2021 SMP Package VI (Hale Avenue, Hoover Avenue, Kernan Drive) Project
Solicitation Number: CO-00360
Job No.: 20-5013 & 20-5512

ADDENDUM 1
August 25, 2020

| RESPONSES TO QUESTIONS |

| CHANGES TO THE PLANS |

SAWS 2021 SMP PKG VI
 SEWER IMPROVEMENTS
 SANITARY SEWER
 QUANTITIES SUMMARY

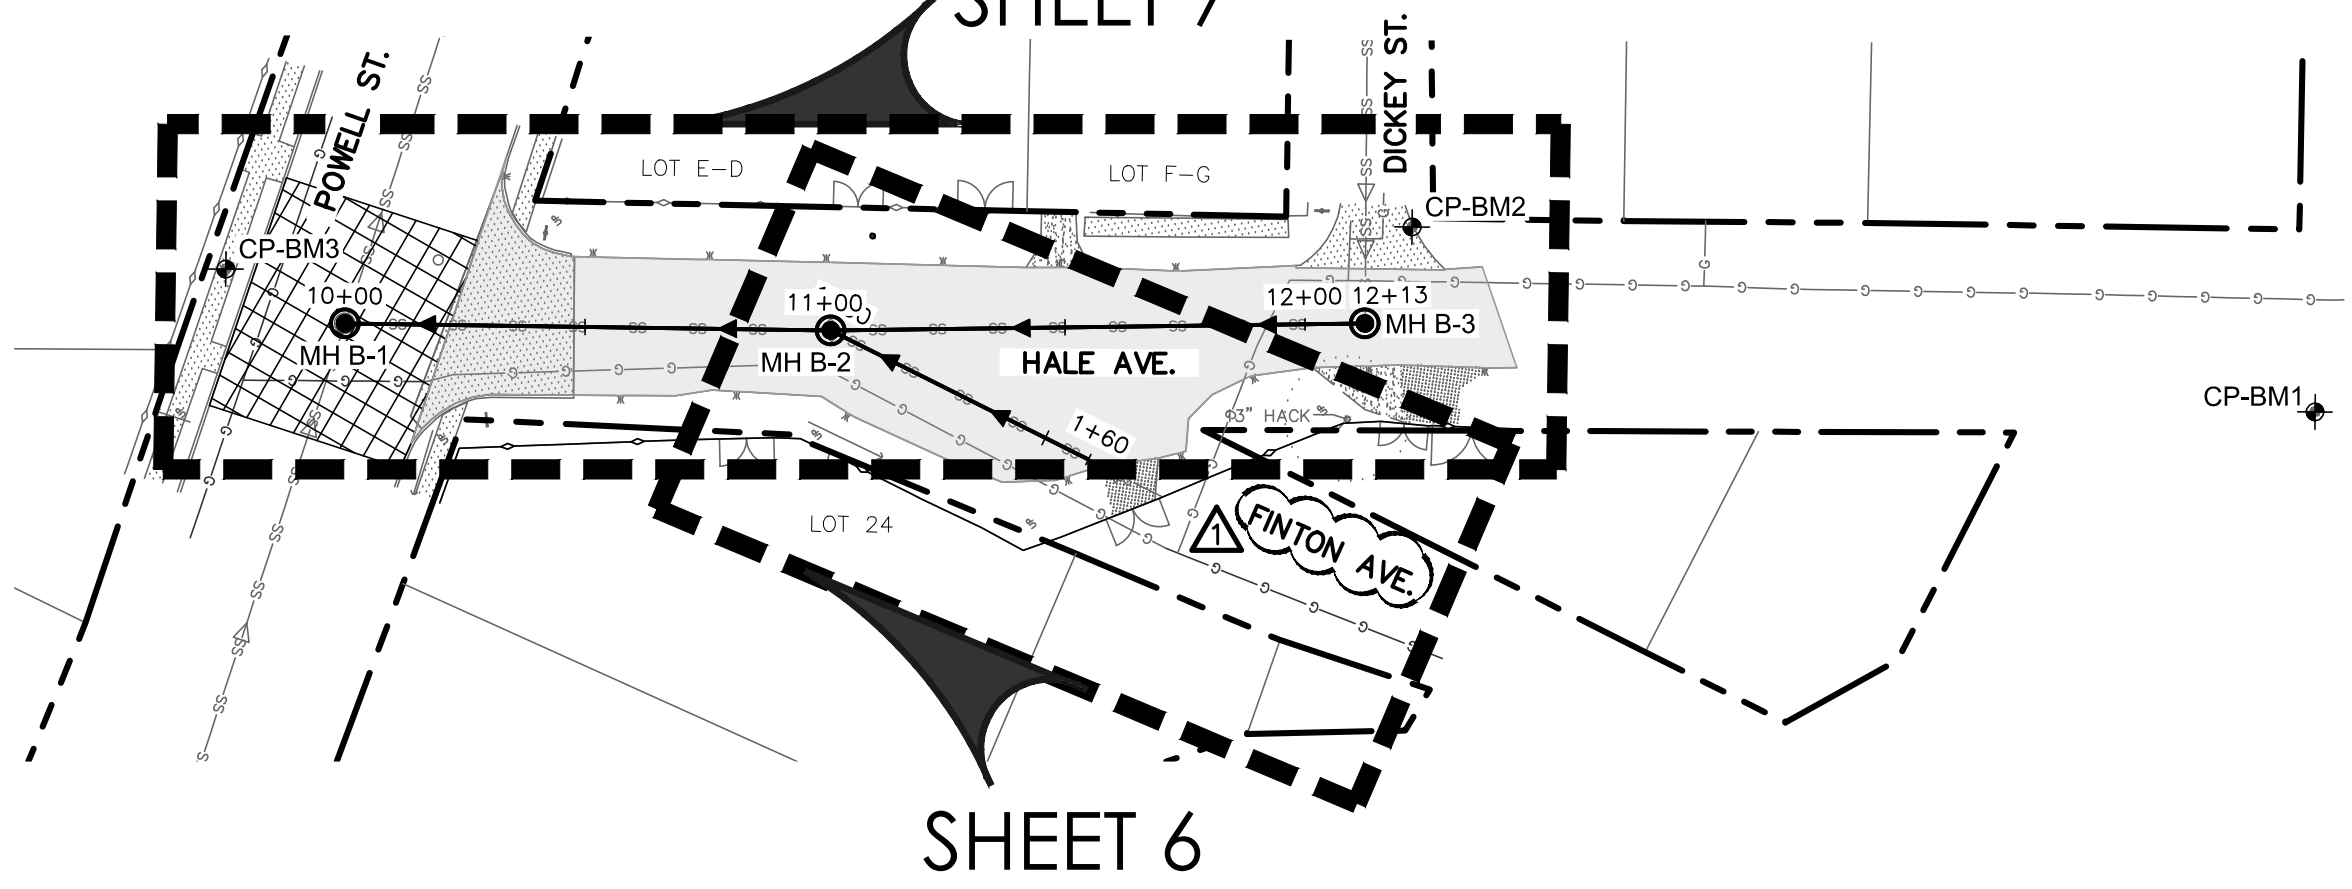
1. Adding SAWS Construction Specification Item 849.
2. Updating flowable fill quantities (see response to question 3).
3. Updated Sanitary Sewer Sheet 7 of 13 (Job #20-5512) to reflect correct quantities.

| PROJECT QUANTITY SUMMARY | | | |
|--------------------------|--|------|---------------|
| 849 | SANITARY SEWER ACCEPTANCE TESTING | LF | 1791 |
